Historic Preservation Design Review

August 27, 2015

HP-15-14, 2 Law Range – Replacement Windows (City)

Below: Photos depicting damage to windows that necessitate replacement.

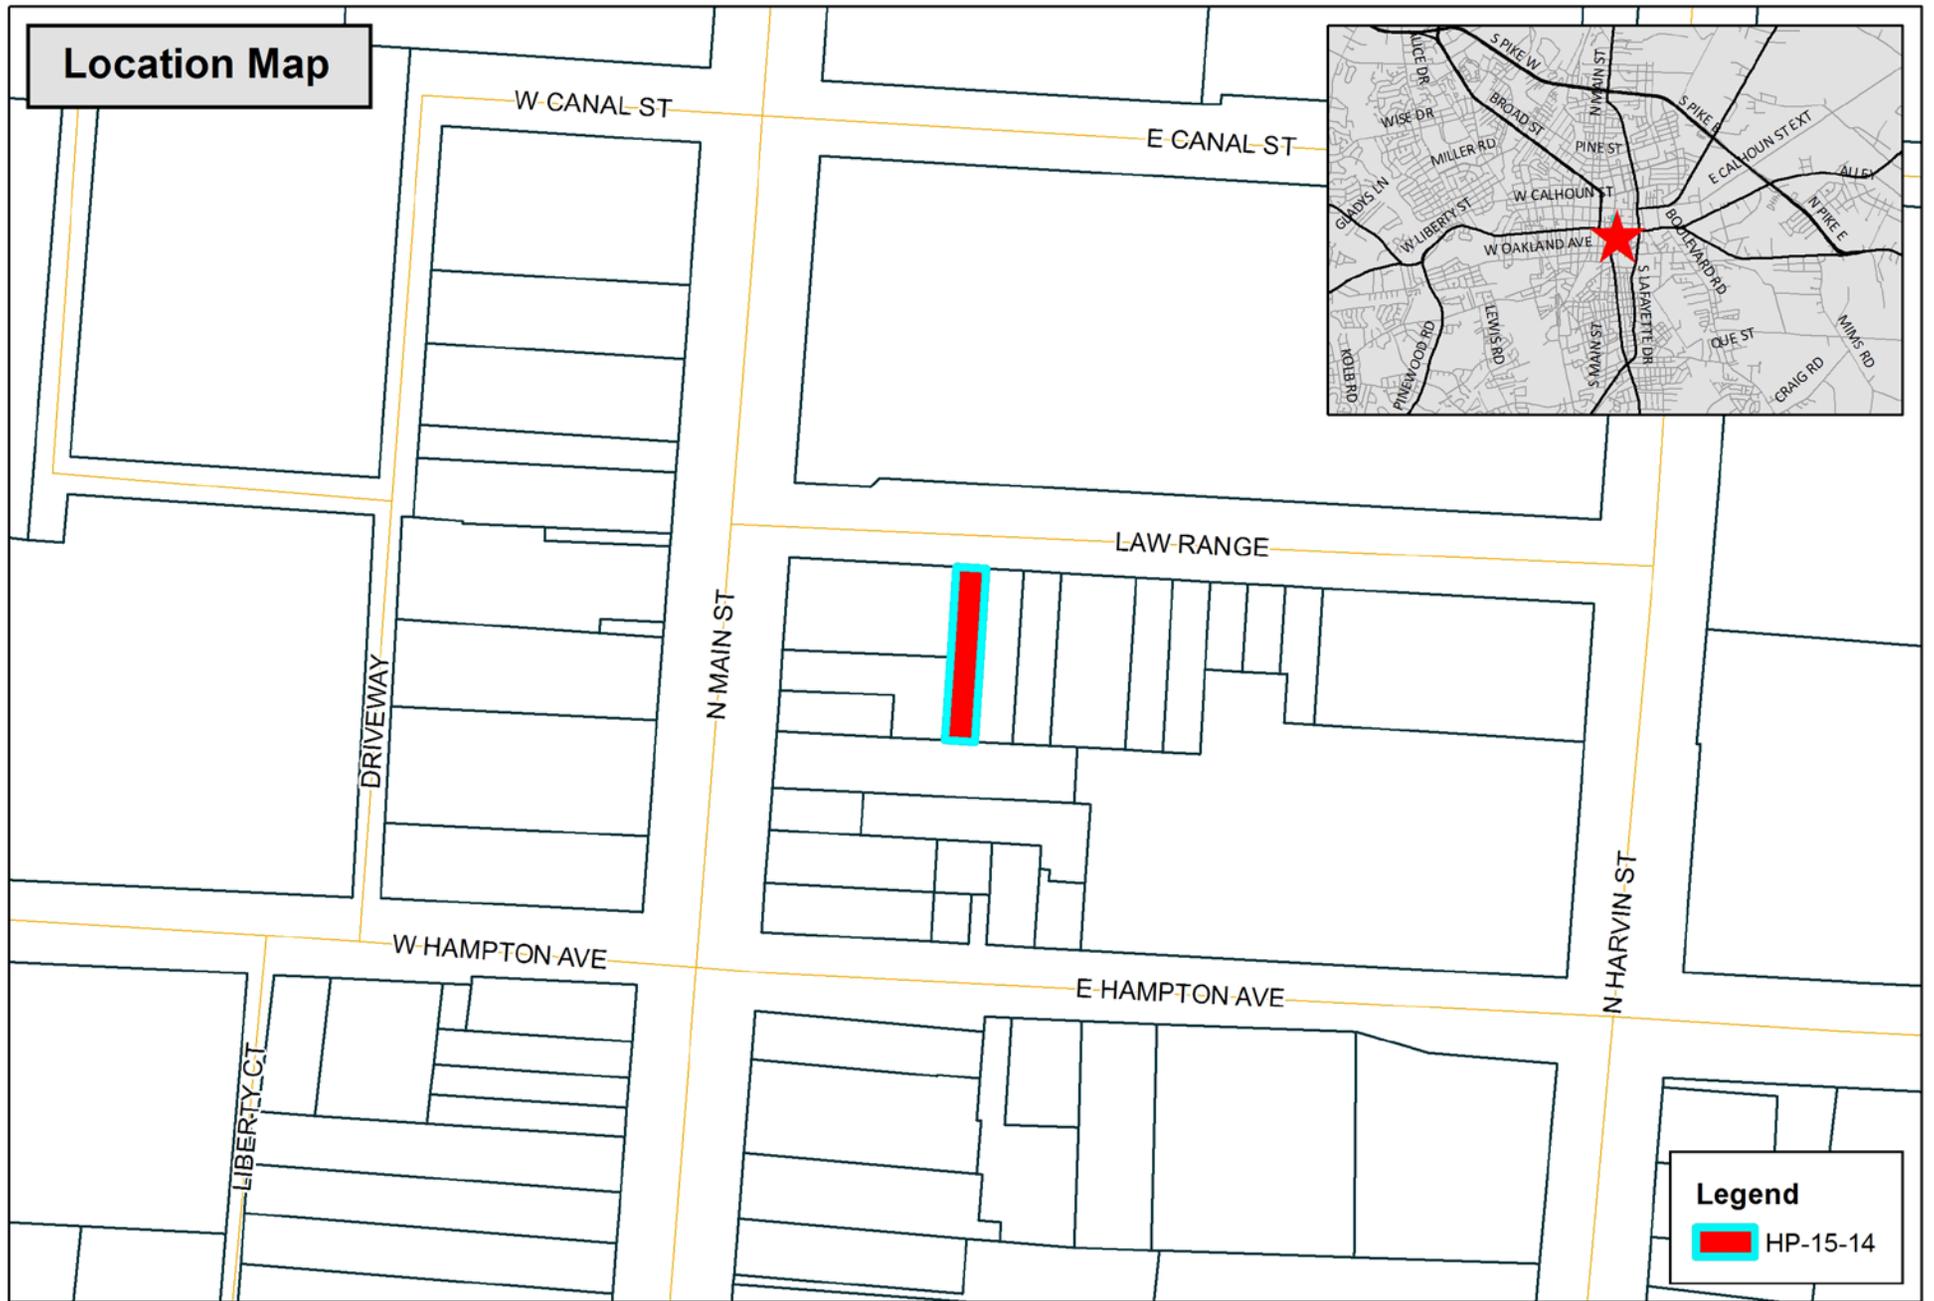
A previous application (HP-07-11) gave approval for the windows to be painted to match the ones at 3 Law Range. Since that time, the windows and frames have deteriorated significantly, and the stone lintel is in danger of collapse in one of them. Water damage and rot have necessitated replacement of the existing wooden windows with Boyd Aluminum - Series 800 single hung windows in white, to match the ones at the adjacent 3 Law Range property. The three upstairs windows are to be replaced immediately, and the property owner is requesting approval for replacement of the three downstairs windows as well, although that work will likely take place at a later date. The property owner also indicated that it is very difficult to regulate temperature inside the building, and is hoping that the use of new, insulated windows will help in this regard.

The replacement windows are metal with a painted finish to resemble wood, and will match the existing on the adjacent side of the building (at 3 Law Range).

Staff recommends approval of this request. The proposed project generally meets the requirements set forth in the design review guidelines. The existing windows are deteriorating, and the replacements will match the originals in design.
